# UNITED STATES PATENT AND TRADEMARK OFFICE

APPLICATION NO.	FILING DATE	FIRST NAMED INVENTOR	ATTORNEY DOCKET NO.	CONFIRMATION NO.
10/722,552	11/28/2003	Ming Fu Teng	BHT-3123-110	8356

# Office Action Summary

This is a first office action on the merits of application SN 10/722,552.

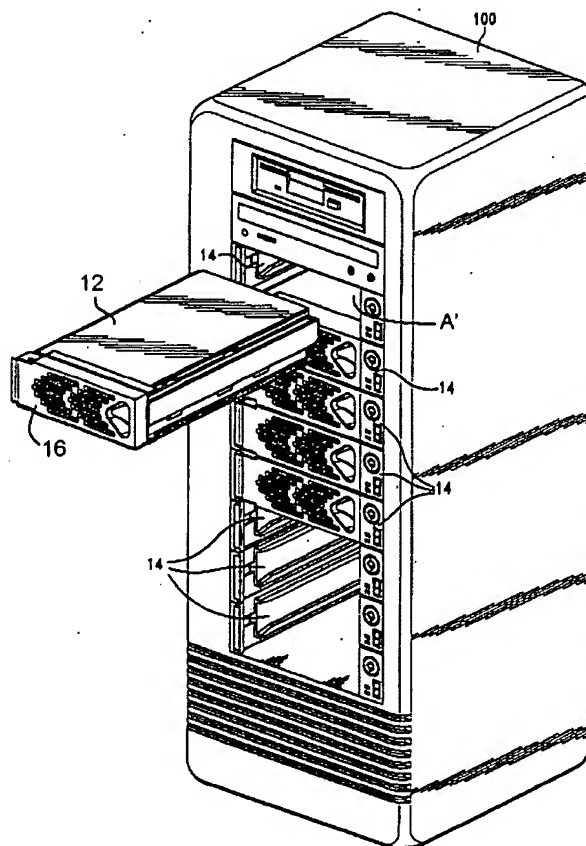
8. Regarding claim 4, the other side of the bay cover (26) has a latch (36) for latching the bay slot (24).

9. Regarding claim 6, the bay cover (26) is substantially convex outside and concave inside, for covering the exposed area of the computer peripheral as best seen in figure 2a and 2b.

Behl '339 Figure 10

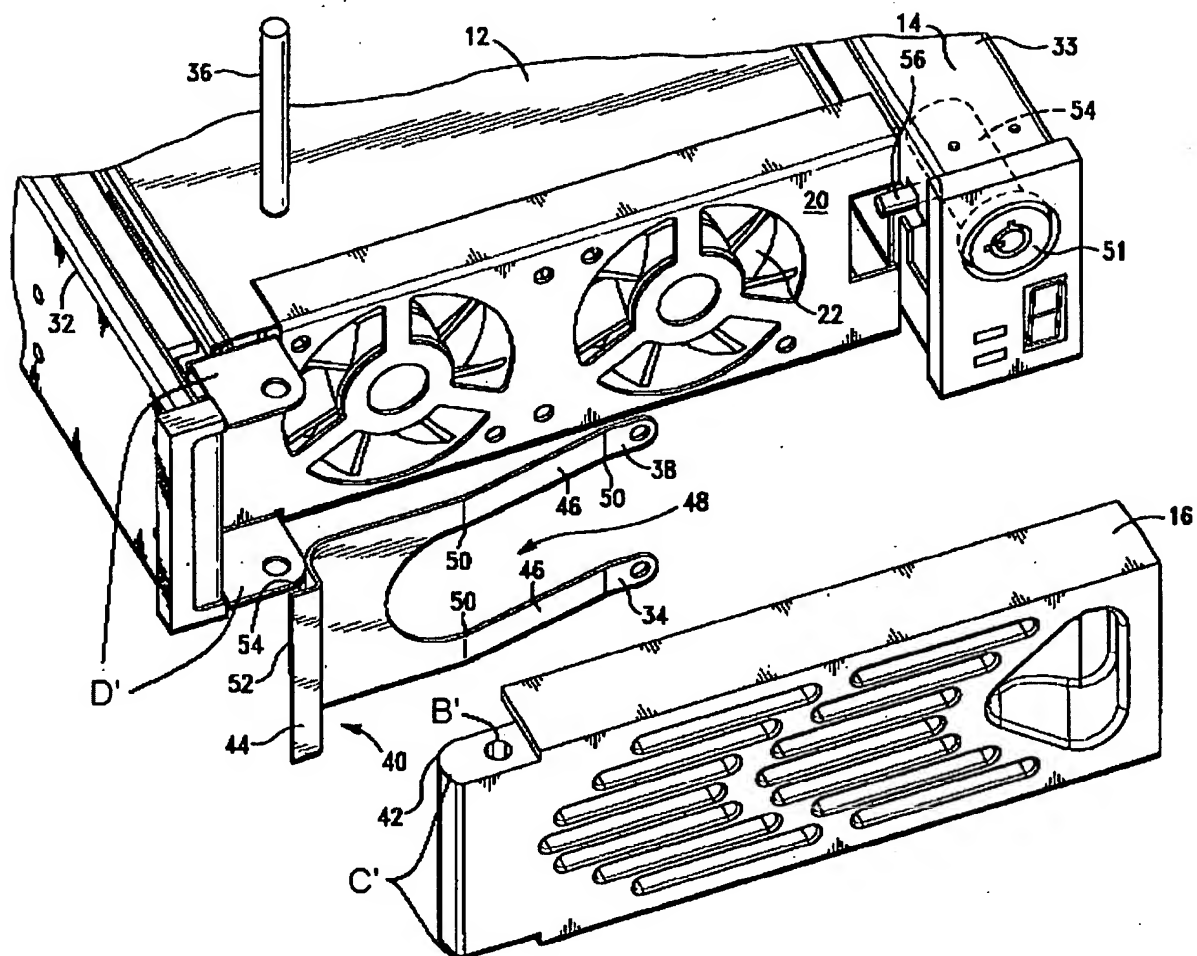
13. Claims 1-3 and 7 are rejected under 35 U.S.C. 102(b) as being clearly anticipated by U.S. Patent 6,193,339 to Behl. Behl '339 discloses a bay cover (16) on a front panel (14) of a computer chassis (100), being covered on a corresponding bay slot (A') on a front panel (14). The bay cover (16) and the bay slot (A') being disposed on the same side and respectively comprise an axle (36) and a corresponding axle hole (B') for movably opening and closing the bay cover (16) so that a computer peripheral (12) can be installed or removed without removing the front panel (14) and the bay cover (16).

14. Regarding claim 2, the bay slot (A') at one end respectively there is an upper and lower symmetrical axle arms (D') extended outward, and the axle arms at their corresponding surfaces on the free end respectively has an axle (36) when the axle is put through the holes on the arms (D').
